Re: Brownfield Cleanup Program Application Resubmittal  
1675 Apartments; BCP Site No. C203107  
1675-1679 Westchester Avenue, Bronx, New York

RE: Brownfield Cleanup Application  
1675 Apartments  
BCP # C203107

**RE: 1675 Apartment, Bronx, NY, BCP Site No. C203107; Draft  
Remedial Investigation Work Plan, dated December 8, 2017**

**PROPOSED SAMPLE LOCATION PLAN**

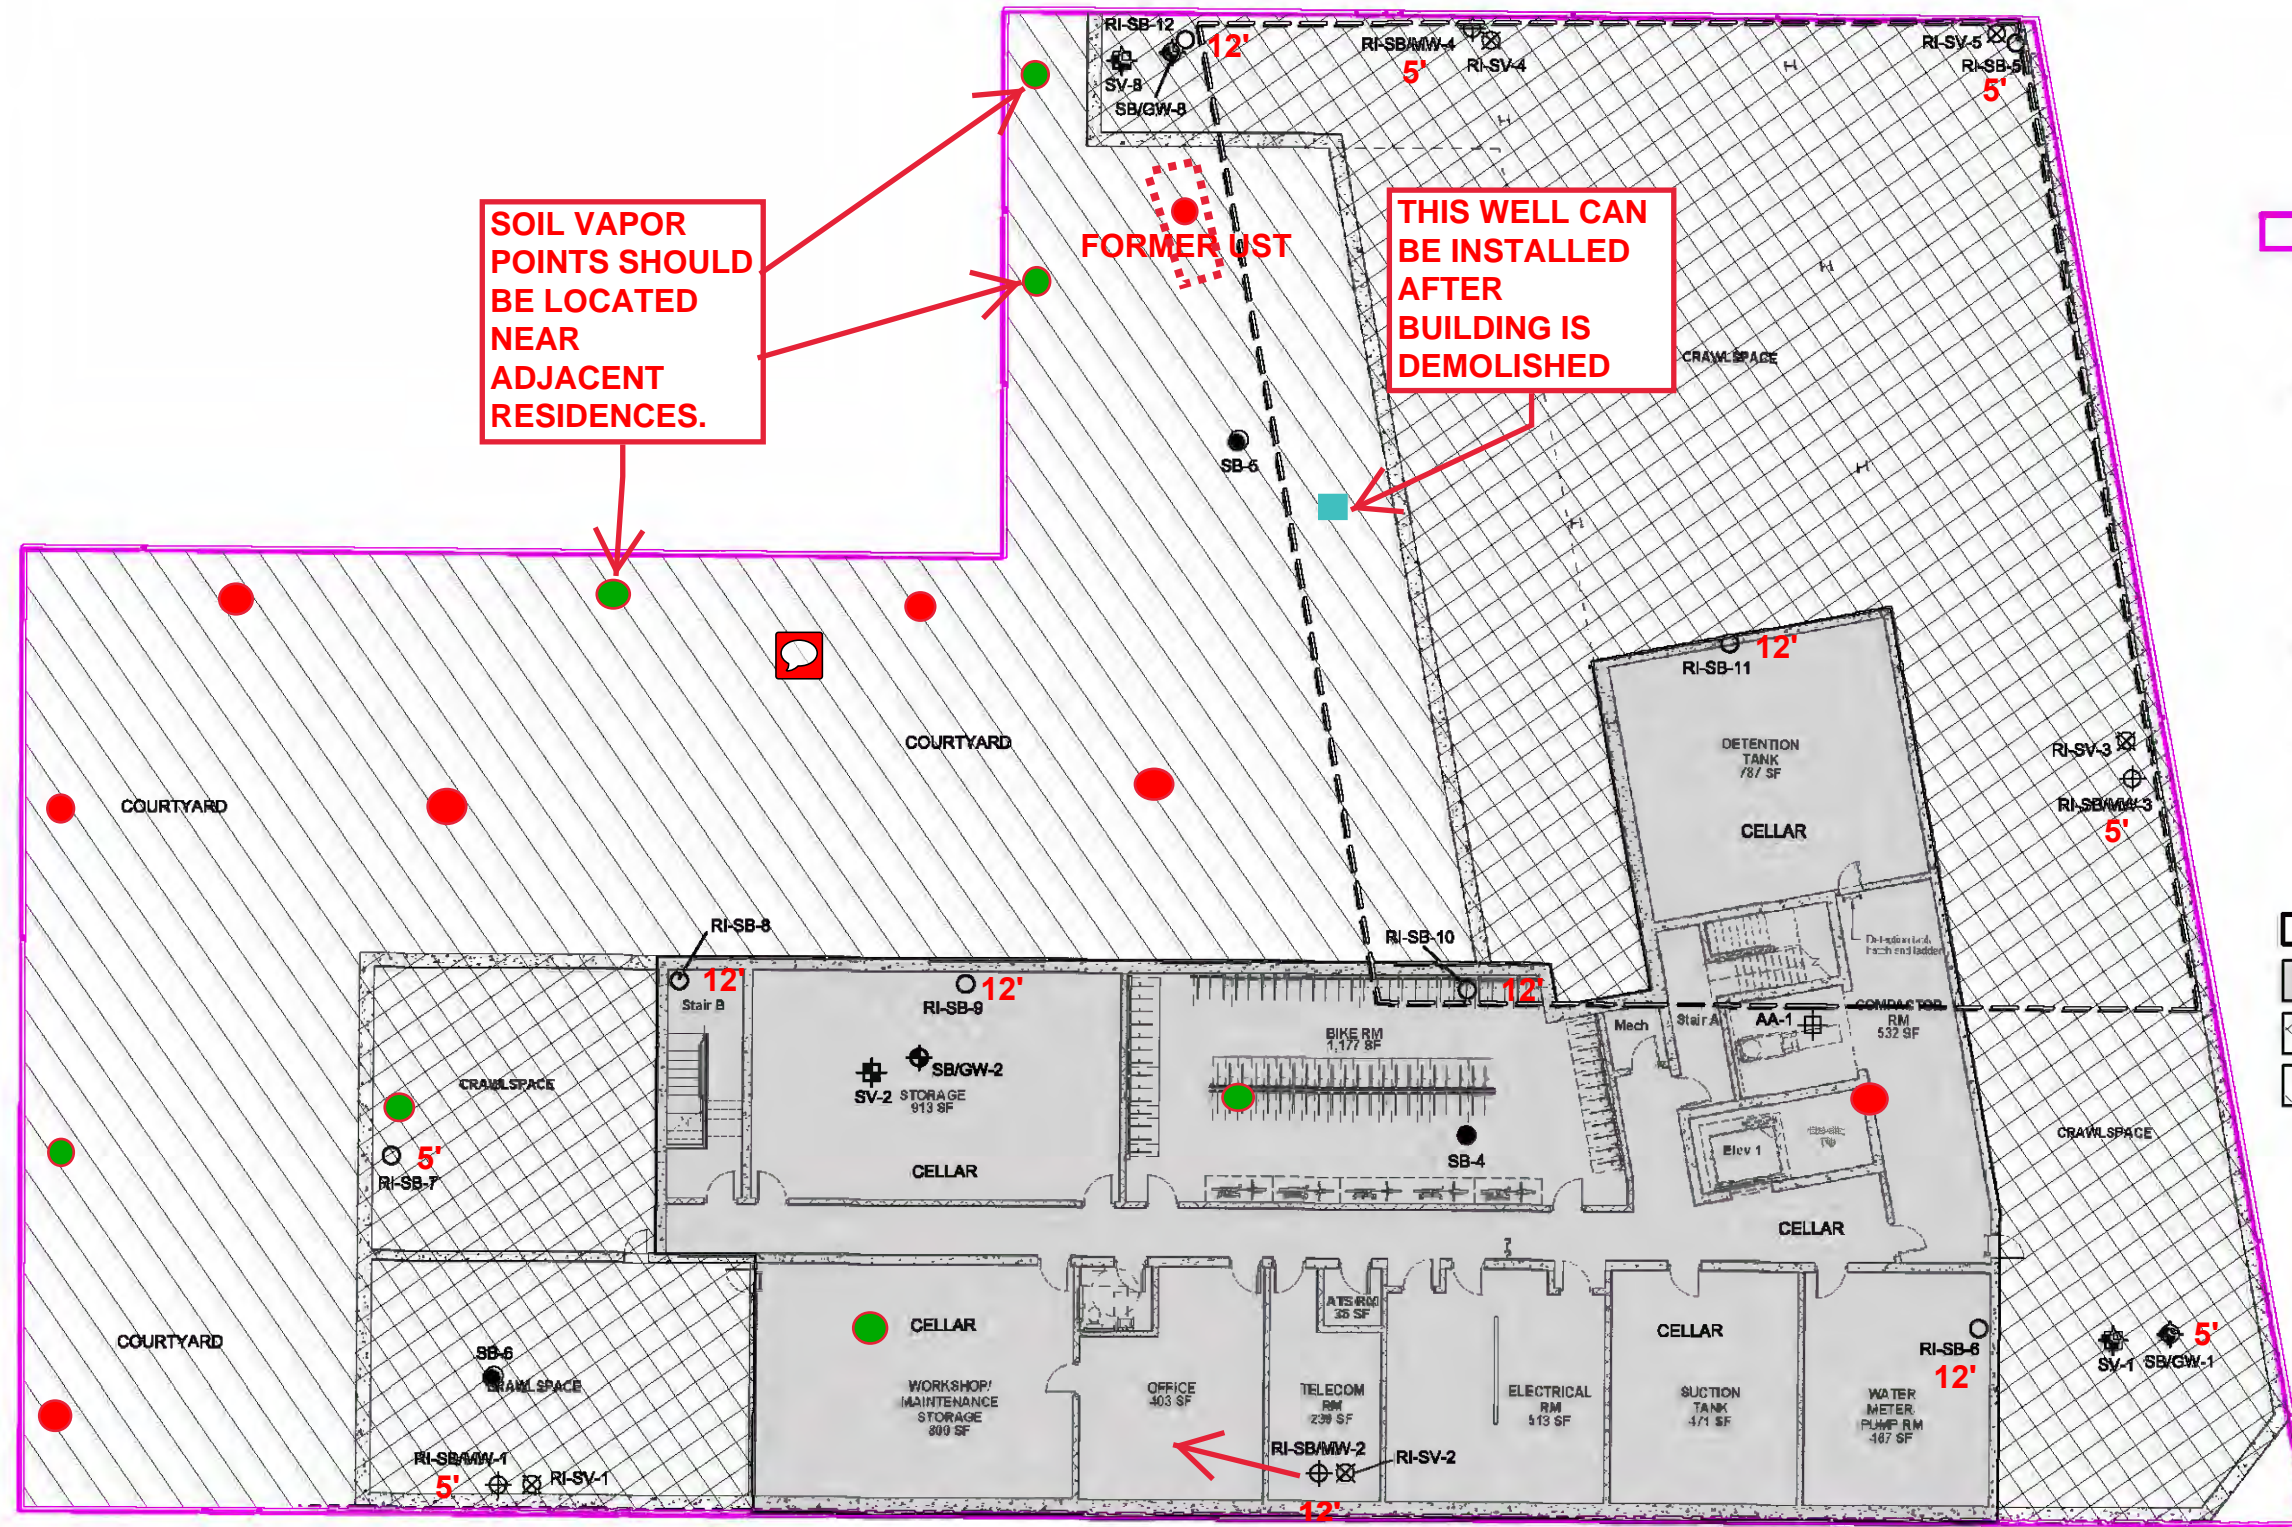
- This section should reference where the qualifications for key project personnel are located in the work plan. (Currently this is in the QA/QC in Appendix A).
- Additional off-site soil, groundwater and soil vapor data will be needed to determine if any contamination is migrating off-site. A BCP volunteer is not required to fully delineate the off-site contamination but must provide off-site data that is sufficient to identify the presence of contamination and support the qualitative off-site exposure assessment. The off-site work can be done now or during the proposed Phase II investigation after there is sufficient on-site data. Reference revised Figure 6.

- Soil sampling depths should go to the water table to fully delineate the depth of any contamination. Explain why some proposed borings only go to 5 feet. Reference section 3.5.2 of DER-10 for guidance.
- In order to fully delineate the site, more soil borings will be needed, especially along the site boundary next to the residences and at the former UST. Reference revised Figure 6.
- There should be a soil boring in the proposed office area to provide information about potential human exposure. Reference revised Figure 6.

#### 4.7 Sub-Slab/Soil Vapor and Ambient Air Sampling (Reference revised Figure 6)

- Additional soil vapor samples are needed where the new building will be constructed. This data is necessary to determine if any sources of contamination are present, especially since PCE was detected at SV-2 and at upgradient locations.

- More soil vapor samples are needed between the residences and the former UST and SV-8, where PCE and other VOCs were detected. Soil vapor can migrate in any direction from a source or former source.

- A soil vapor point is needed at the proposed office area to evaluate potential human exposure.
- It appears that RI-SV3, 4 and 5 are actually sub-slab samples since they will be collected from underneath the building slab. Preferably, they should be collected during the winter heating season and away from building walls.

**Need off-site soil, groundwater and soil vapor data to determine if any contamination is migrating off-site.**
